# Energy & Climate Report for EIA

Climate impact assessment of the coal to gas conversion of the thermoelectric power station “Federico II” in Brindisi

Figure 1. Source: TERNA – Italian Adequacy Report 2019 (Rapporto Adeguatezza Italia 2019)

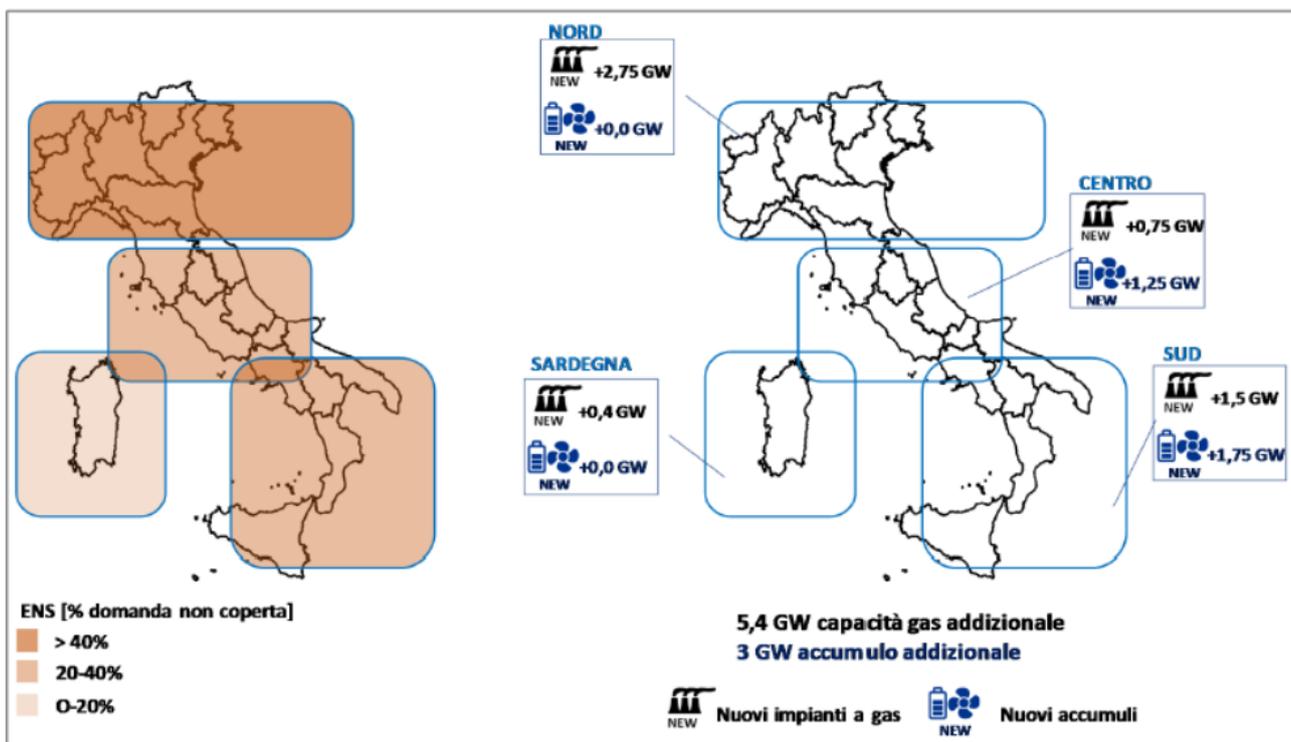
According to Terna’s 2019 Adequacy Report,<sup>20</sup> it is calculated that **1500 MWe** of new fossil gas-fired power is needed to compensate for the closure of coal-fired power and meet national grid adequacy requirements in Southern Italy, as shown in the picture below:

The new plant “Federico II” alone would exceed this requirement with its **1680 MWe** (or even 1730 MWe as stated by Enel depending on the technological development of the individual machines being used).

However, as already set out in the previous section, the new gas-fired power plant in Brindisi would already be redundant with respect to Terna’s Adequacy Report which, as we recalled, envisages a total new thermoelectric capacity of 1.5 GW in Southern Italy. And even in case of a project with reduced capacity in Brindisi, if one considers all the other investment plans in new gas capacity, Terna’s indications are already largely exceeded, as indicated in the previous section.
